TO: Historic Landmarks Commission

HEARING DATE: October 17, 2024

CASE NO.: Historic Design Review Case No. HIS24-16

APPLICATION SUMMARY: A proposal for new turf, fencing, lighting, and hardscape improvements to Willamette University baseball facilities at Willamette's Spec Keene Stadium.

HISTORIC DESIGN REVIEW
 SHEET TITLE
ILLUSTRATIVE PLAN - PROPOSED CONDITIONS
 SHEET #

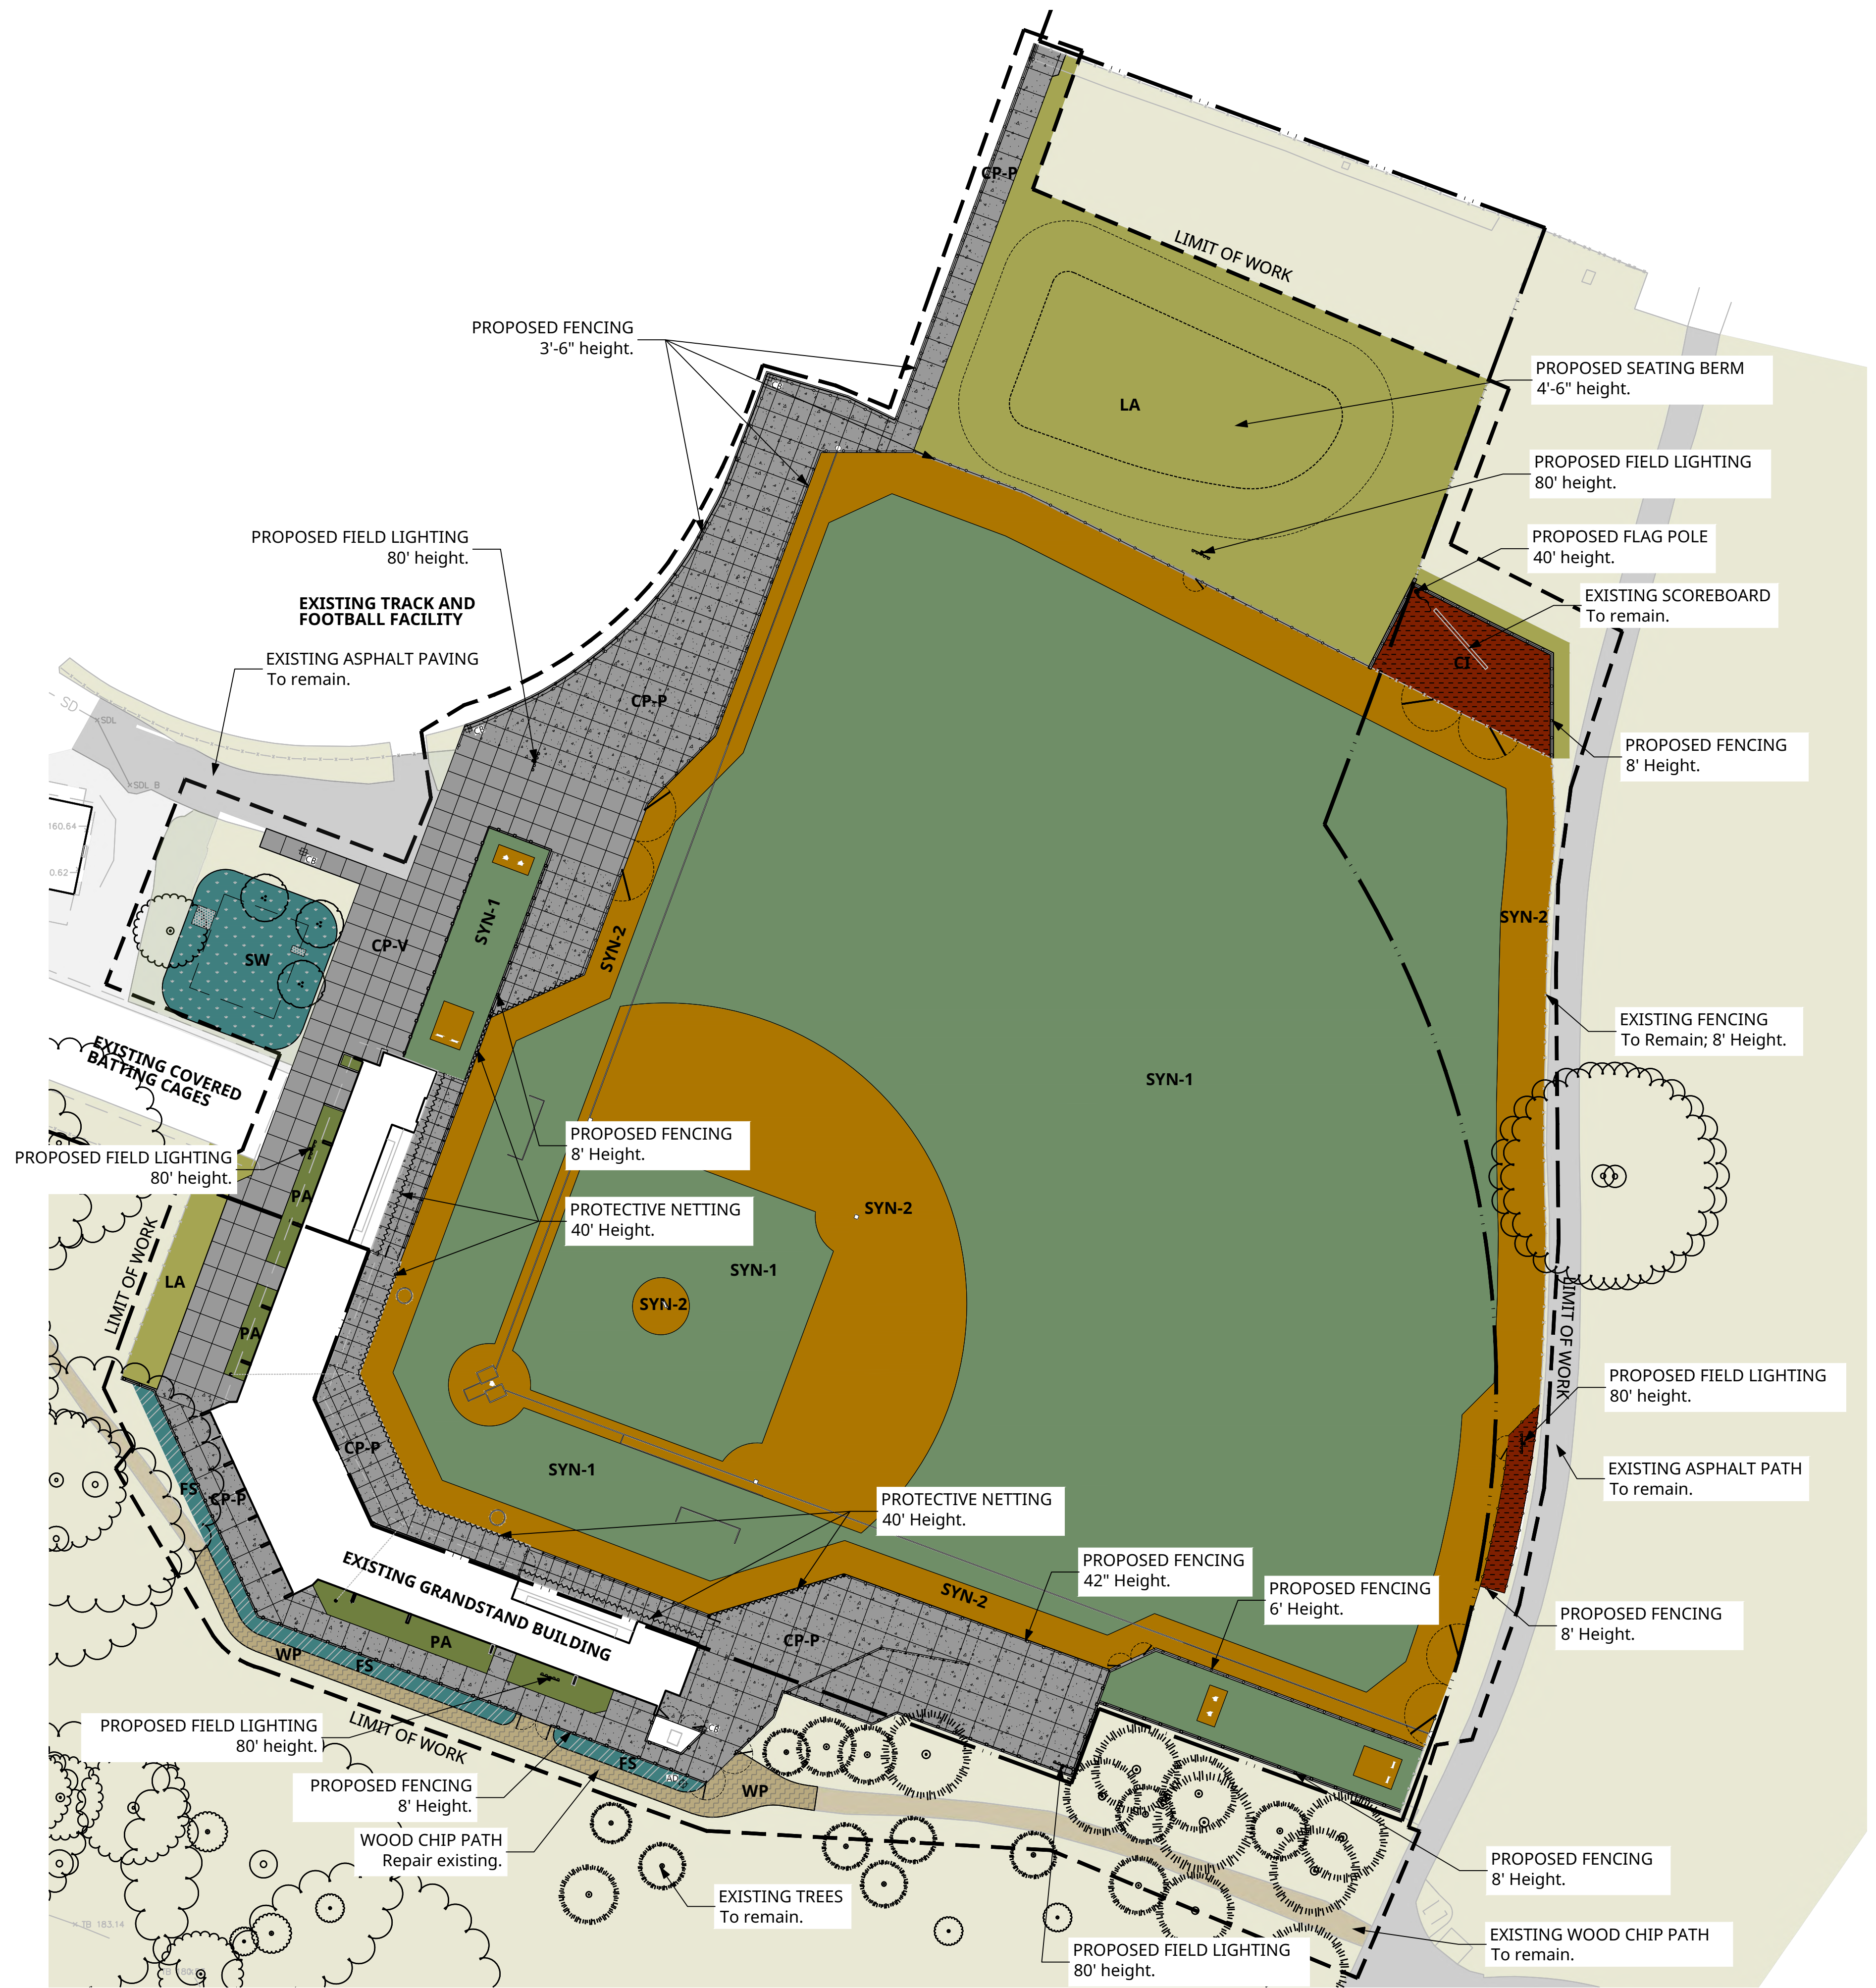
6. *The proposed relocated gate, a new public entrance south of the existing grandstand will threaten contributing vegetation in the Lower Pasture; and there is no pedestrian lighting between this location and Leffelle Street (Lingo).*

1. The Illustrative Plan of Proposed Conditions (Sheet LH2.00) of the historic application graphically shows a new double gate in the new fencing south of the existing grandstand building. This is a change from the existing gate location which is currently further west. Although the gate and fencing are non-contributing, this change will adversely impact contributing vegetation resources outside of this gate. The existing gate is a service gate for maintenance personnel use. The relocated gate is identified on the Land Use application as an entry to the facility (Sheet L1.00, key note 3.10). This new public entrance/exit to the facility will threaten contributing vegetation in the Lower Pasture by encouraging high levels of pedestrian traffic through the extensive grassy area at night, to and from events where liquor is served, after the park is closed. There is no pedestrian lighting between this location and the nearest street, Leffelle St. Leffelle St is approximately 600 feet south of the subject property.

The HLC does not regulate access or egress, therefore does not have the regulatory authority to restrict access to or from the South Gate; To clarify, the proposed gate is a secondary gate, which already exists on the south side of the field, the proposal is to relocate it. The HLC also does not regulate pedestrian lighting for new development. However, the encroachment agreement approved by City Council in 2024 commits Willamette University and the City of Salem to an annual review, which requires an assessment of the impacts on the park and surrounding community related to pedestrian impacts, parking, noise, and light impacts. Any unintended impacts shall be addressed before the Agreement is renewed.
